### 1 Products affected

### 3 Detailed description of change

Product Change Notification					PCN Type FAS		
owner	creation date	release date	released by	change order no	rev	page	D10-000-818
zbindeja	2016-01-05	2016-06-15	bergerra	2008835	A	1 of 2

Old product appearance	New product appearance

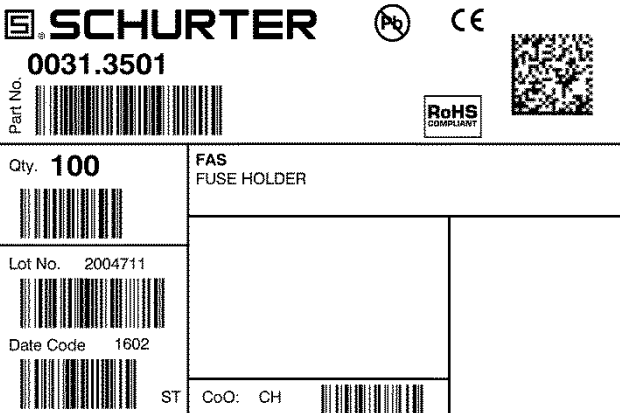
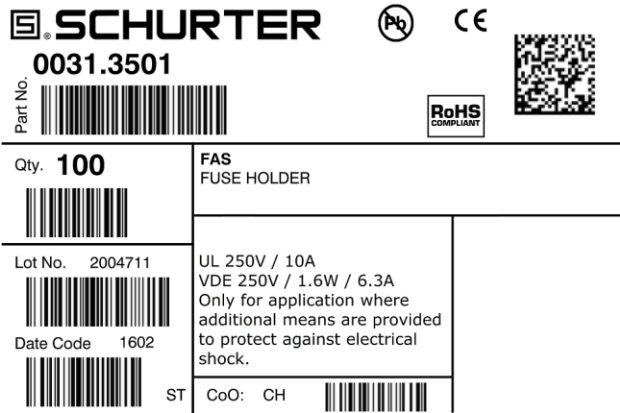
1. Modification of approval marks
2. Modification of label
3. Material change

- Recertification by VDE
- Product improvement to fulfil the enhanced glow wire requirements according to the updated standard IEC 60127-6 and the standard IEC 60335-1 for appliances in unattended use.
- New approval by cURus.

Form	No	There are no form changes, only markings adjusted
Fit	No	There are no dimensional changes
Function	No	This is a non-functional change
Production Site	No	There is no change of the production site
Product Label	Yes	VDE and cURus marks added. Electrical ratings added.
Customer Action	No	Notification only

Old product approval	New product approval
VDE	VDE cURus
